In response to your application dated January 31, 1977, as amended by filing dated December 22, 1977, the Commission has issued the enclosed Amendment Nos. 26 and 20 to Facility Operating License Nos. DPR-42 and DPR-60 for the Prairie Island Nuclear Generating Plant Unit Nos. 1 and 2, respectively. The amendments consist of changes in the Technical Specifications that relate to provisions for Fire Protection.

AMENDMENT TO FACILITY OPERATING LICENSE

Amendment No. 26
License No. DPR-42

ATTACHMENT TO LICENSE AMENDMENT NOS. 26 AND 20

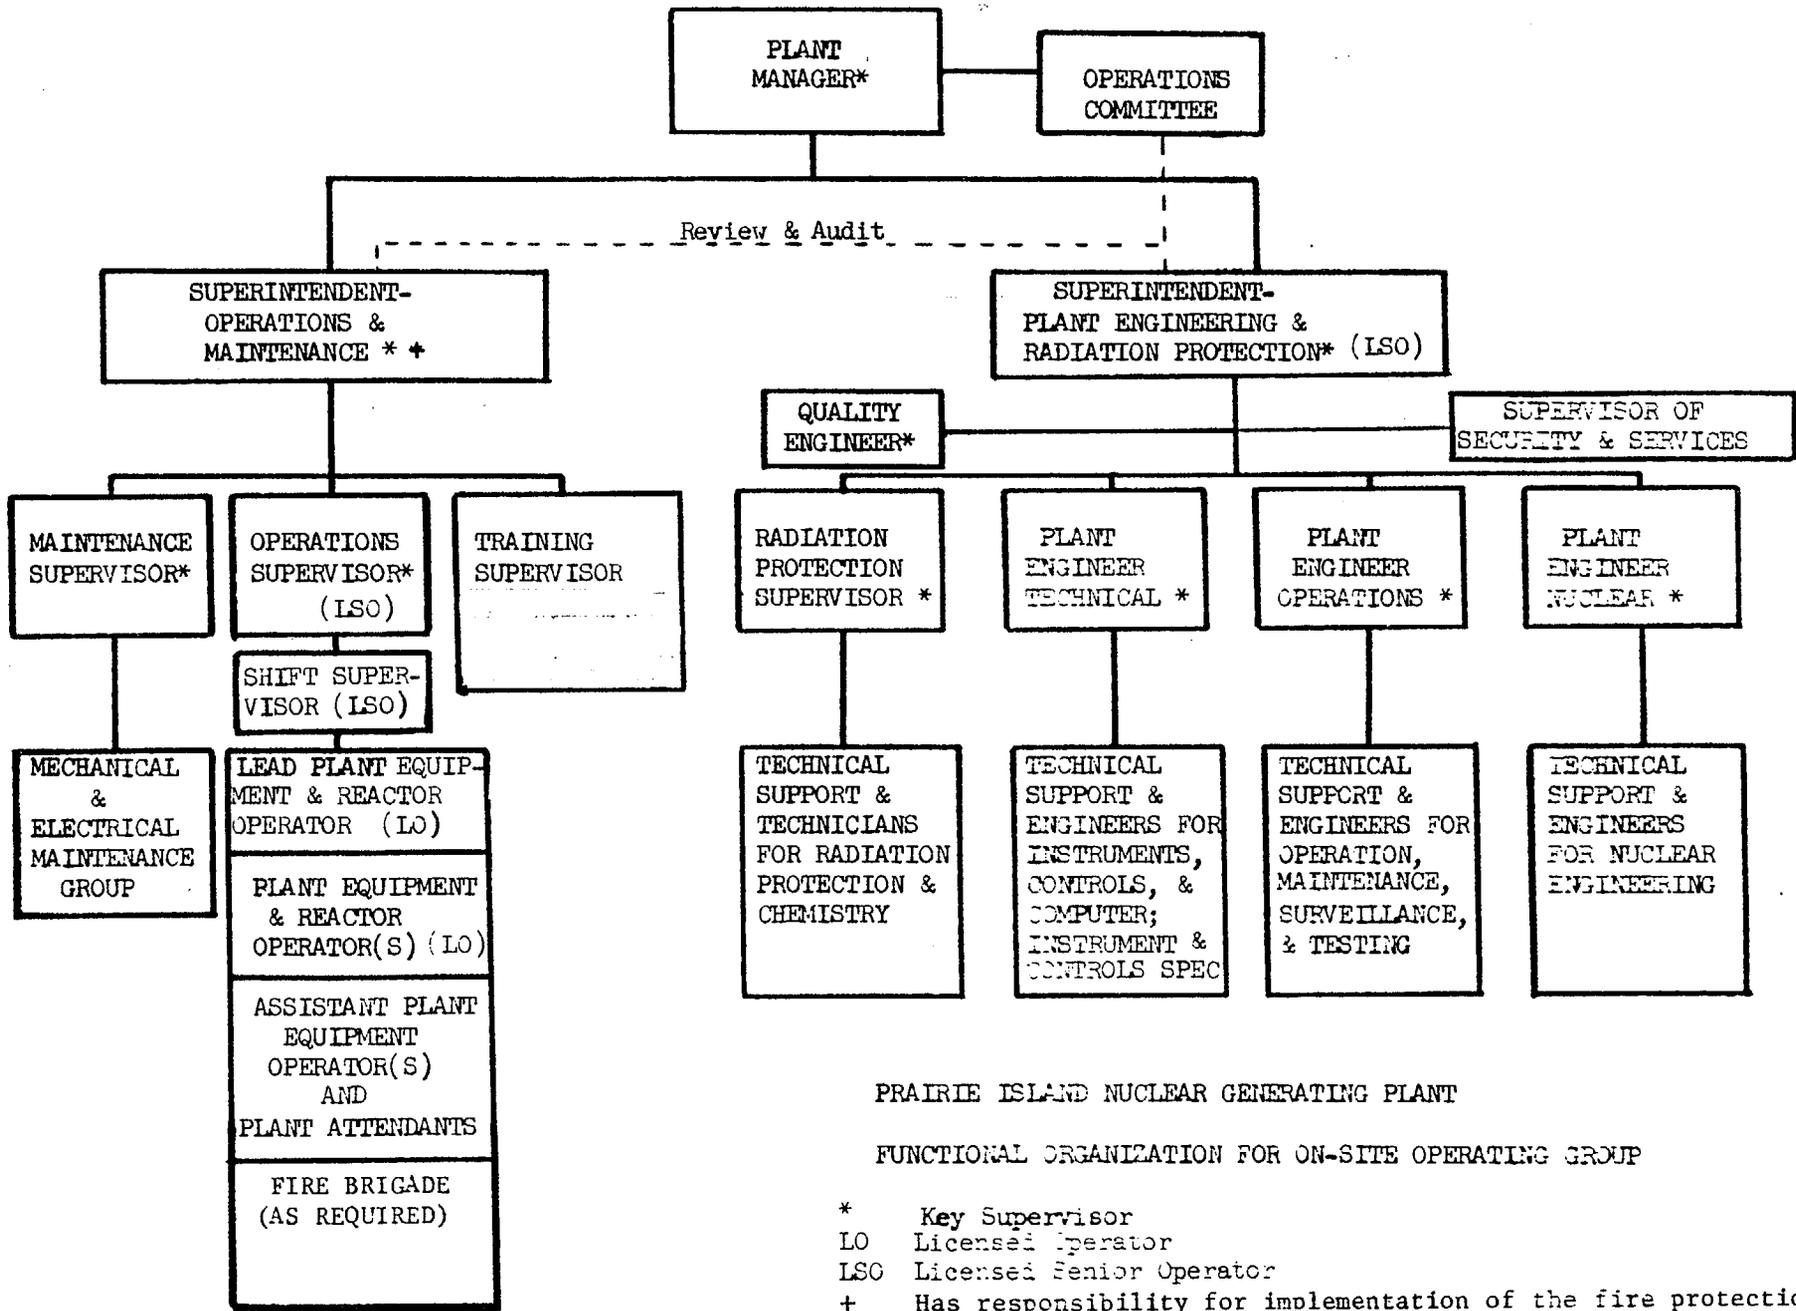
Your change for 6.1.C.6 requires a fire brigade of three members rather than the five members. Additionally, Figure 6.1-1 will not have the specific delineation of fire protection responsibility and Figure 6.1-2 will not have specific delineation of operator and fire protection training responsibilities under the Training Supervisor.

- B. The Northern States Power corporate organizational structure relating to the operation of this plant is shown in Figure TS.6.1-1.
- C. The functional organization for operation of the plant shall be as shown in Figure TS.6.1-2 and:
